HIDEOUT, UTAH PLANNING COMMISSION REGULAR MEETING

2. Shoreline Phase 2 Amended and Phase 3: Consider Final Subdivision Approval

Staff Review for Planning Commission

Re: Shoreline Phase 3 (and Amended Phase 2)

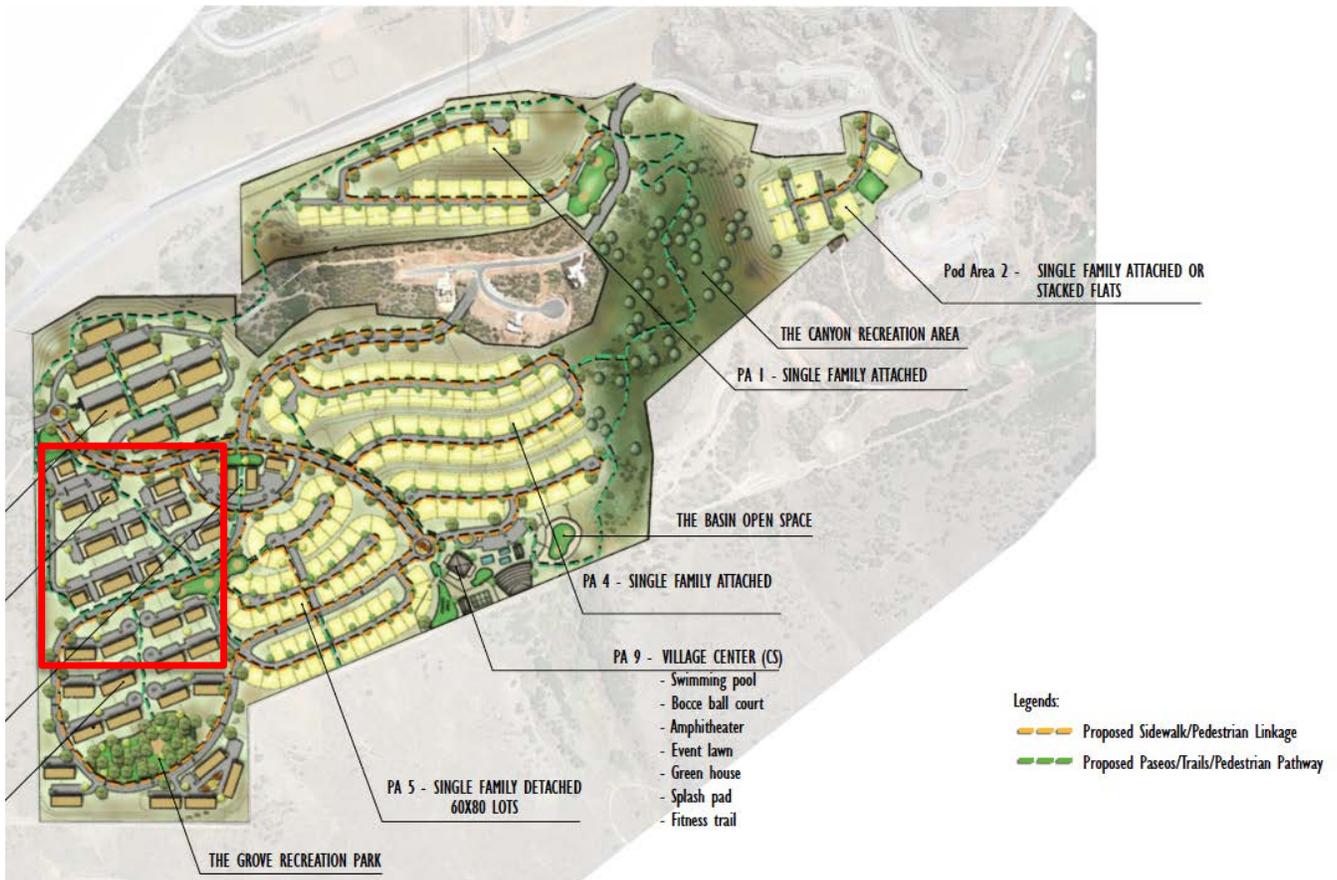
11. Note #1 in the 'Notes' on the Phase 2 Amended Subdivision and Phase 3 Subdivision states that *'all common area is to be considered a drainage and public utility easement.'*
 - a. The Applicant has not illustrated the existing Public Utility Easement(s) on the proposed subdivision plan. These specific areas should be shown on the proposed subdivision.
 - b. This note should be revised to identify the areas that are common areas for HOA use vs. those areas that will be designed for green drainage infrastructure and those that will be used as parks, trails and open space.

The Applicant has not yet addressed this requirement.

Exhibit A – 2010 Master Development Agreement (MDA) RSPA Zoning Map

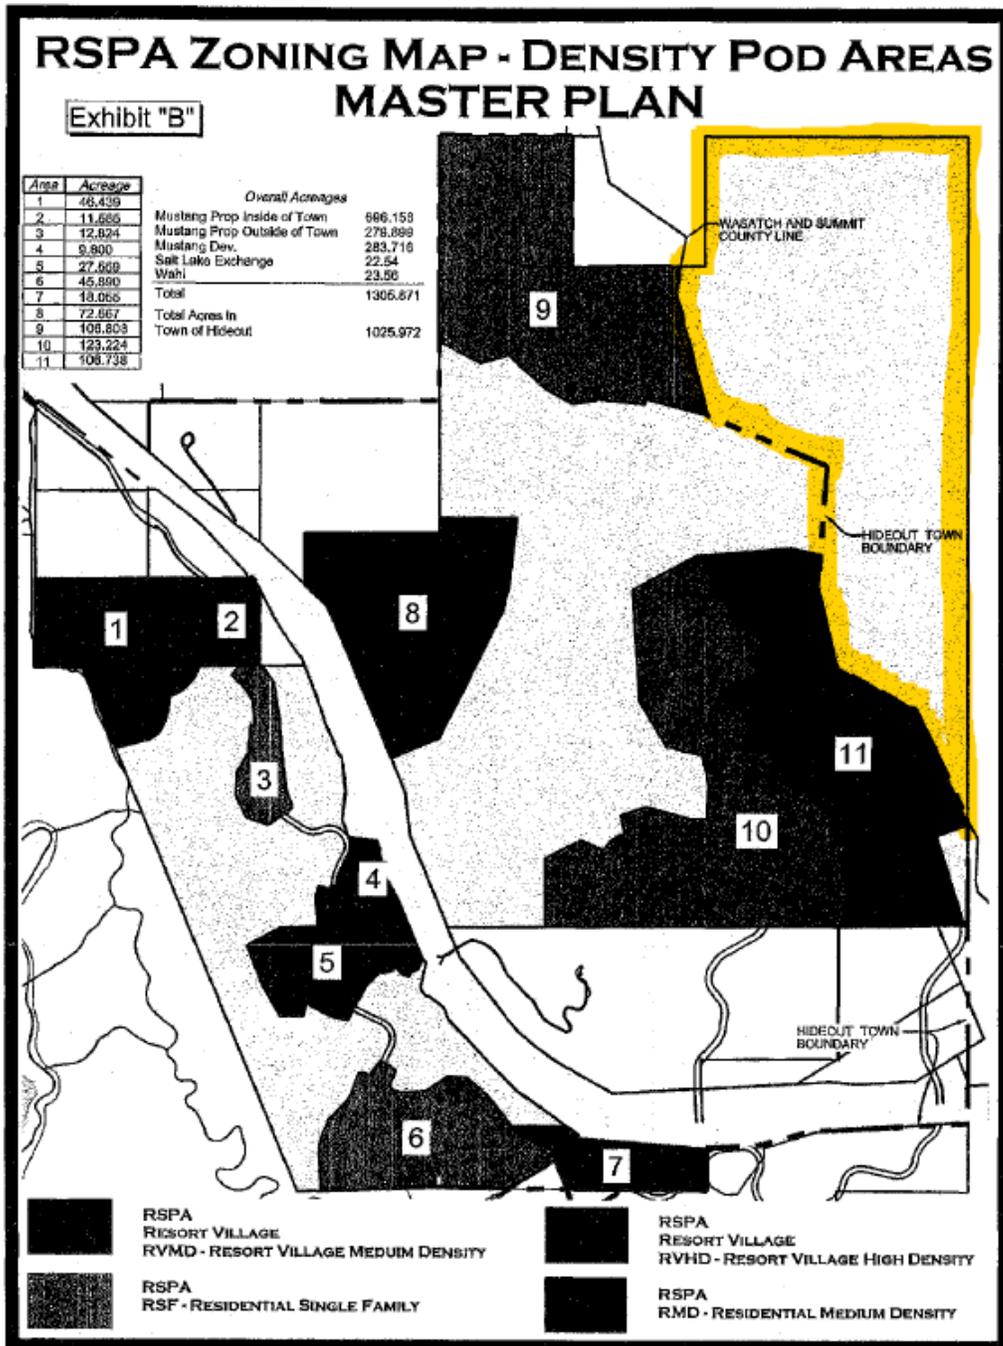
5. Zoning: The RSPA (Resort Specially Planned Area) map is referenced several times relative to the overall 2010 MDA. The map is contained in Exhibit B. A color rendition should be provided for Staff review since the black and white copy makes it hard to decipher the exact locations of specific density/subdivision pods.

A detailed review of the 2010 MDA indicates that the Master HOA does not include all of the required elements per the RSPA (Resort Specially Planned Area) and is out of compliance with the 2010 MDA. Pursuant to Section The MDA must comply with the RSPA Zoning District as per the Town Code, Section 12.30.06
